CEN/TC 267/WG 8/MHD « Maintenance of EN 13480 series »

Answers to MHD Questions of 2021

Series EN 13480-1-2-3-4-5-6 and -8:2017

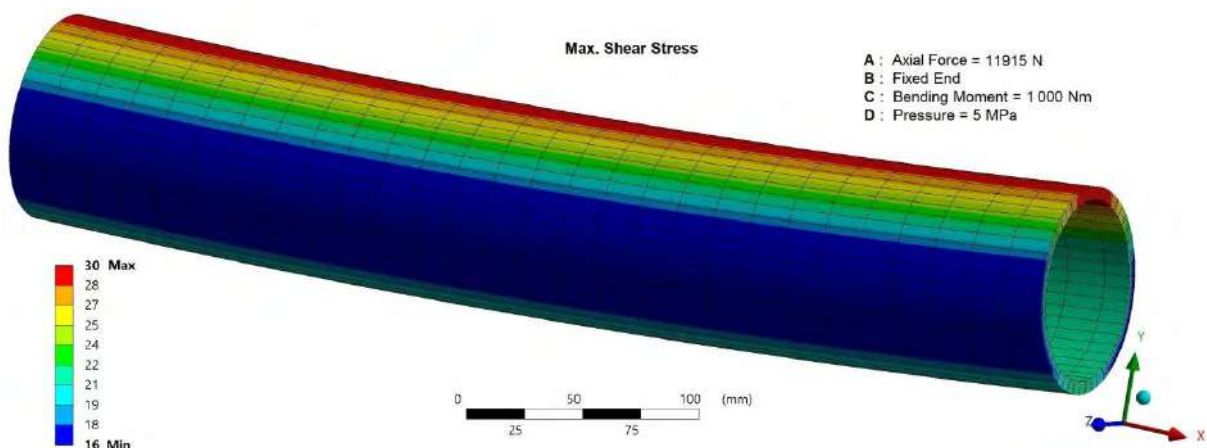
To crosscheck if the statements written above are valid (and not a ghost hunt is done) a simple ANSYS finite element model is created.

This contains a pipe with $d_o = 88.9$ mm and $e_c = 5.5$ mm and is fine meshed (five HEX20 elements over the wall thickness). On this pipe an inner overpressure of 5 MPa is applied. One end of the pipe is held fixed and on the other end a static bending moment of 1 000 Nm (= 1 000 000 Nmm) and a variable axial force $Q_{x\Sigma}$ representing $p_c \cdot \pi d_i^2 / 4 + Q_{xS}$ is applied.

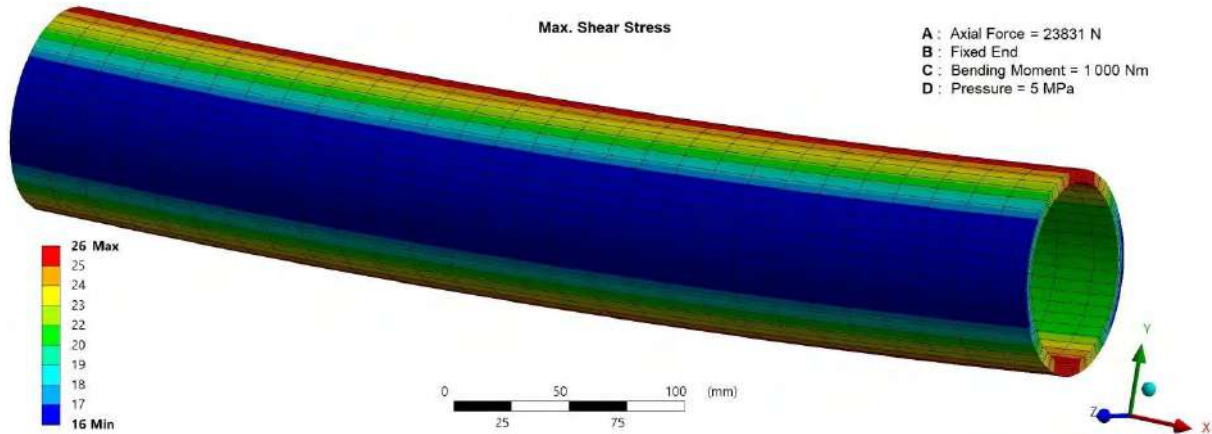
The results show that for $Q_{x\Sigma} < p_c \cdot \pi d_i^2 / 4 = 23831$ N the upper part of the pipe (compression side) gets the higher shear stress:

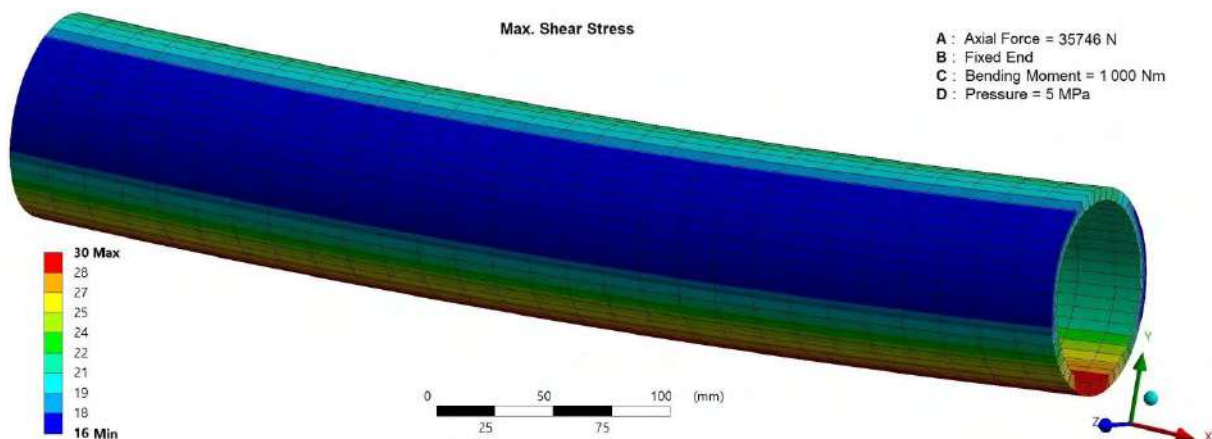
The results show that for $Q_{x\Sigma} = p_c \cdot \pi d_i^2 / 4 = 23831 \text{ N}$ the upper and lower parts of the pipe get the same shear stress and also the maximum shear stress gets the lowest overall value:

**Pipe 88.9 x 5.5 with inner overpressure $p_c = 5$ MPa (50 bar),
bending moment $M = 1\ 000$ Nm, axial force = $Q_{x\Sigma}$**

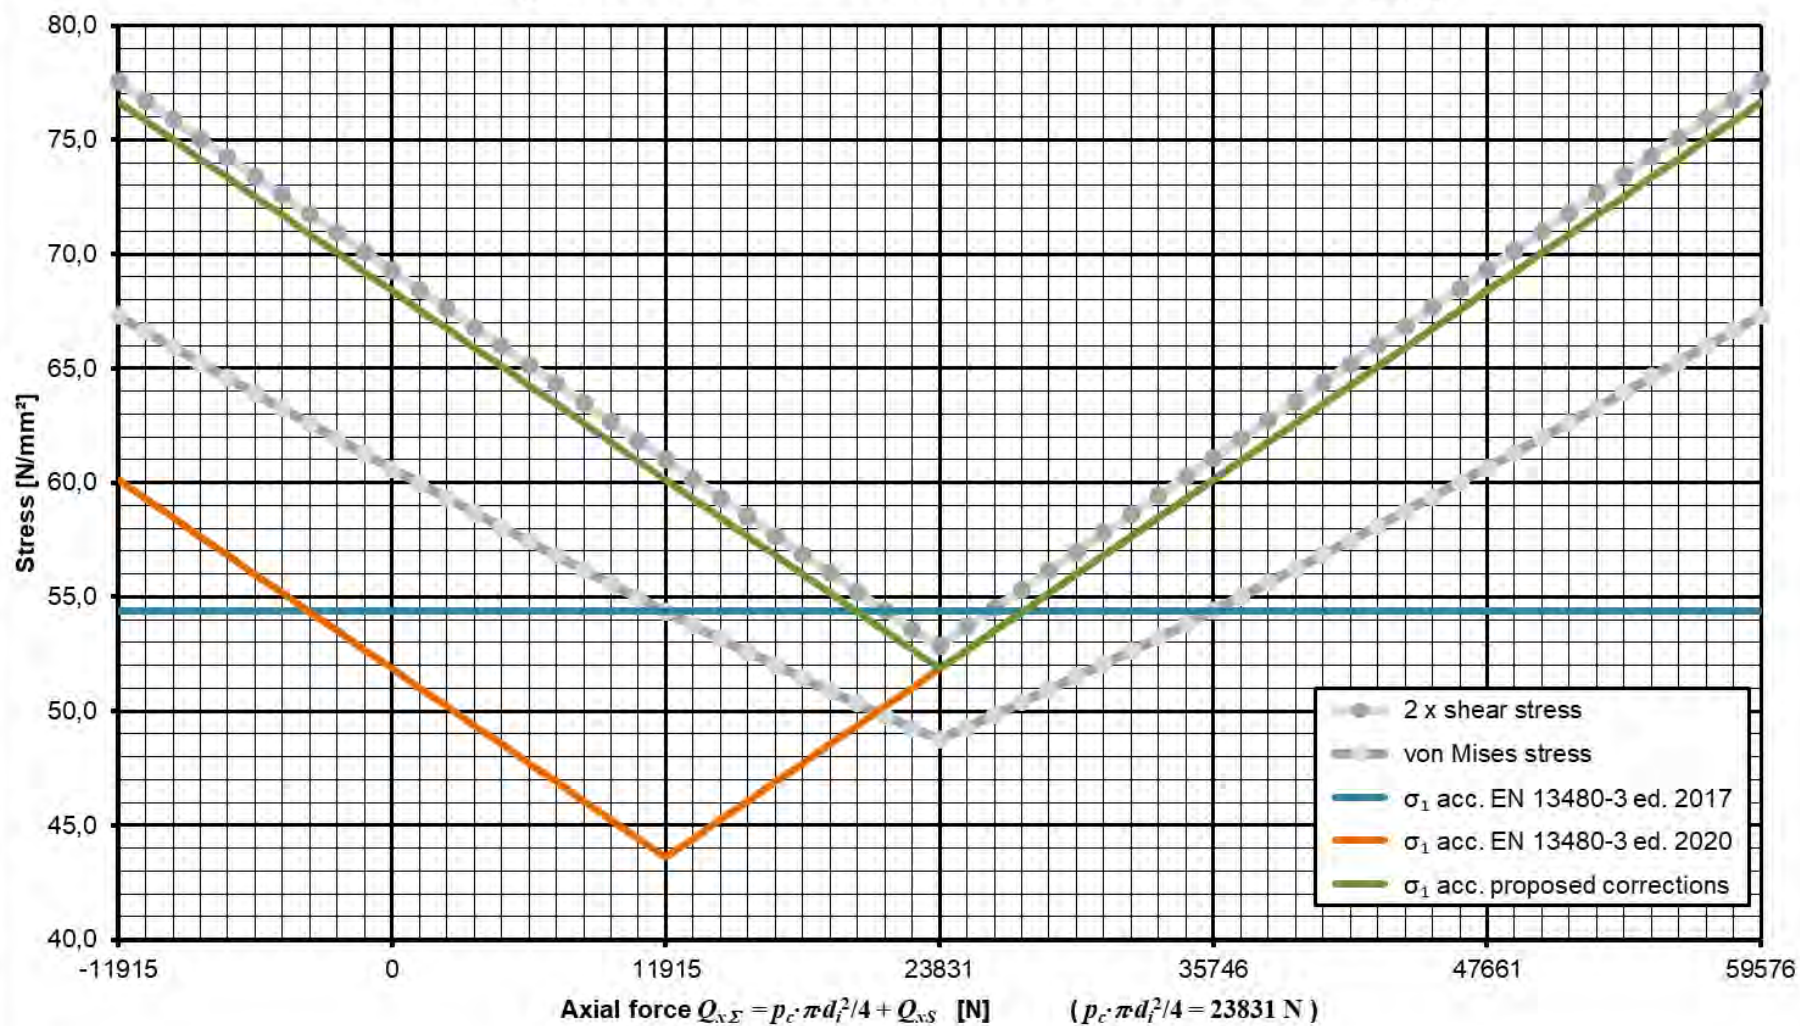
The following diagram provides a comparison of the shear stress results and the von Mises stress calculated with ANSYS and the values given by equation (12.3.2-1) of EN 13480-3 editions 2017 and 2020 as well as for the proposed corrected equation.

This also shows that if $Q_{x\Sigma} > p_c \cdot \pi d_i^2 / 4$ the equation (12.3.2-1) (equation (12.3.3-1) analogue) in EN 13480-3 edition 2020 provides good results. However, if $Q_{x\Sigma} < p_c \cdot \pi d_i^2 / 4$ this equation gives to low stresses while the equation with the proposed corrections still gives good results.

Therefore, the previously written statements regarding the necessity to correct the equations in chapter 12 in EN 13480-3 seem to be valid.
